United States Department of Justice
Environment and Natural Resources Division
Telephone (303) 844-1372
Facsimile (303) 844-1350

June 29, 2009

Re: United States' comments on the Preliminary Hydrographic
Survey Report for the Hopi Indian Reservation

Figure 1: Average monthly solar radiation based on data from NCDC SA station 3103.

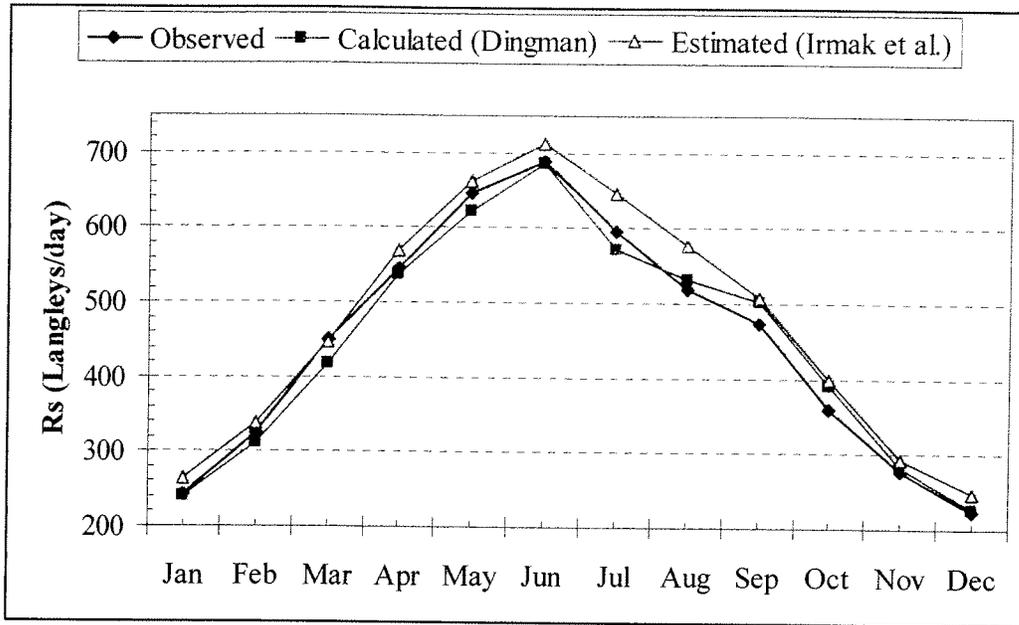
ADWR’s climate analysis is inadequate for two reasons. First, the HSR uses limited climate data and does not attempt to adjust these data for location. This is an important process and calculations are easily performed. ADWR did not use the full climate record available at the Keams Canyon station. As Shown in Figure 1 below, ADWR’s method of radiation calculation is not the best method available for the region, overestimating measured radiation at the Flagstaff station.

Daily solar radiation was calculated by the United States as a function of day of the year, the dew point temperature (*T_{dew}*), and the total sky cover (*T_{skc}*), using equations from Dingman (1994). These values were adjusted within PRMS for aspect, elevation, and slope. ADWR used the Hargreaves Method. The United States compared measured radiation at Flagstaff to the Dingman and Hargreaves method as presented in Figure 1. The Hargreaves method overestimates radiation in this comparison.

Figure 2: Example of corn spacing on the Hopi Reservation.

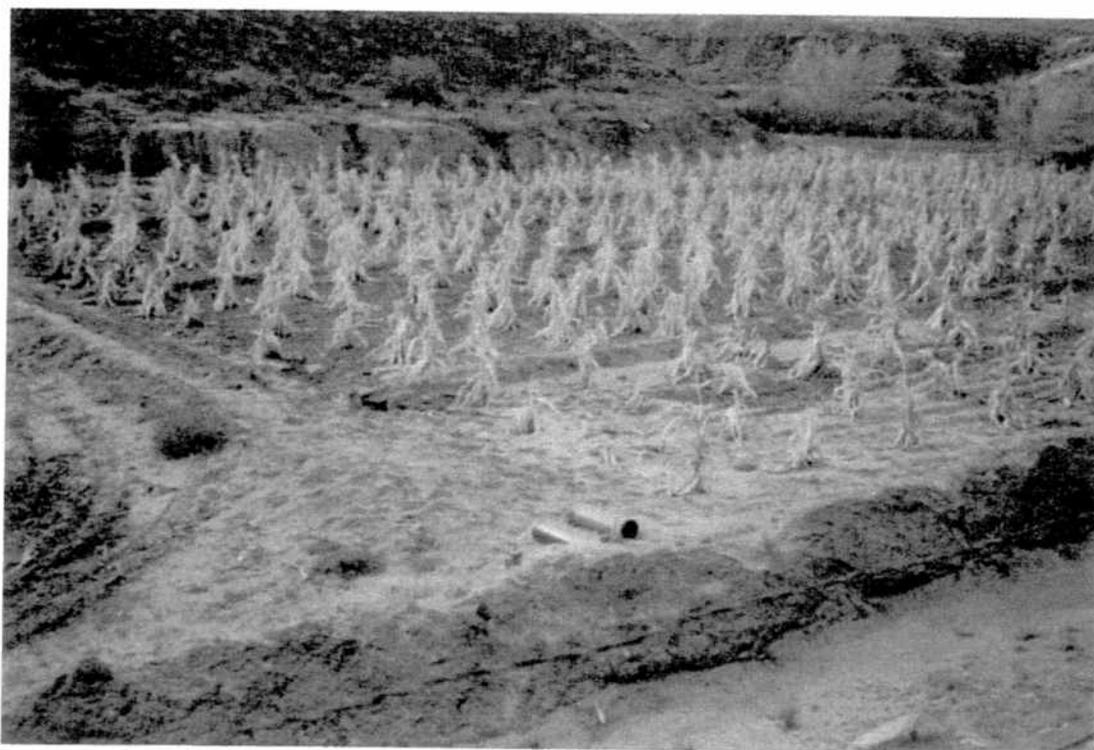
As listed in Table 2, the HSR peak coefficient is considerably lower than the already-reduced estimates by the United States. ADWR justifies this by estimating crop spacings at a minimum of 8-12 feet and a maximum of 15-20 feet. However, ADWR's own photos show this spacing to be unreasonable (see photo figures in Appendix F in ADWR Hopi HSR). Figure 2 shows a typical field; for scale the tire tracks at the left of the photo should be no more than 12" wide. Clearly crop spacing is not 8-12 feet.

Figure 3. Example of Basal and Average Crop Coefficients from National Engineering Handbook.

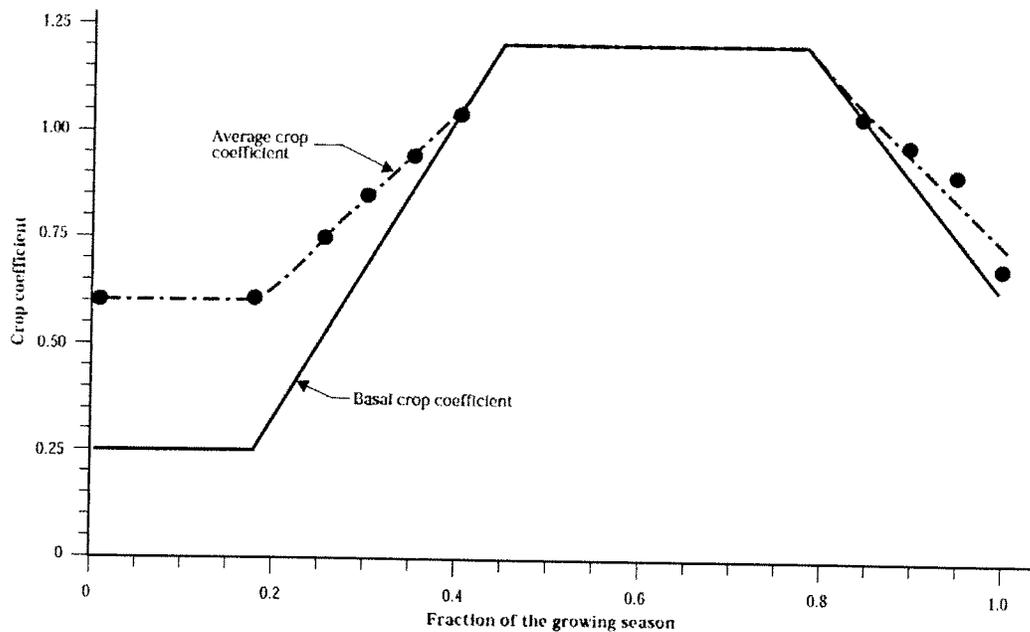
Both the United States and ADWR used the methods outlined in Food and Agriculture Organization of the United Nations, Publication 56 (FAO, 1998) to estimate crop coefficients. Both claims adjusted the crop coefficients (Kc) to represent the less than ideal growing conditions observed on the Hopi Reservation. ADWR estimated the plant spacing at 8-12 feet between rows and clumps of plants. ADWR estimated the peak crop coefficient for corn at 0.36, using a method described in FAO 56. However, the methodology is applicable to adjustments in the basal crop coefficients, not the Kc mean. Kc basal only includes plant transpiration and evaporation beneath the vegetation canopy; therefore, if effective cover is never obtained the soil evaporation component needs to be included. Additional water use or demands are needed to account for the evaporation from the soil surface during and after a precipitation events or irrigations. The combined or average (evaporation and transpiration) Kc for the crop is 1.0 for the day of a rain decreases over the following days depending on the soil type. Similarly, upon irrigation the Kc combined is also increased to account for soil evaporation. For crops with a small percentage of effective cover the soil evaporation is a significant contributor to crop ET.

The proper method for estimation of water use when adjusting for non-standard conditions is described in the FAO 56 manual and Part 623 Irrigation of the National Engineering Handbook (NEH, 1993). Figure 3 is an illustration from the National Engineering Handbook Part 623, Chapter 2, page 2-90. If the crop coefficient is less than 1.0 due to less than 100 percent effective cover than the average coefficient is greater than the basal crop coefficient. This is particularly important because most crops grown on the Hopi Reservation never reach effective cover due to the crop spacing.

ADWR made an adjustment for “DRY” referred to as dry land, based primarily on the crop spacing of corn. ADWR’s definition of dry land is crops grown without irrigation. While precipitation farming was a land use category, the United States did not estimate a water requirement for the precipitation farming.
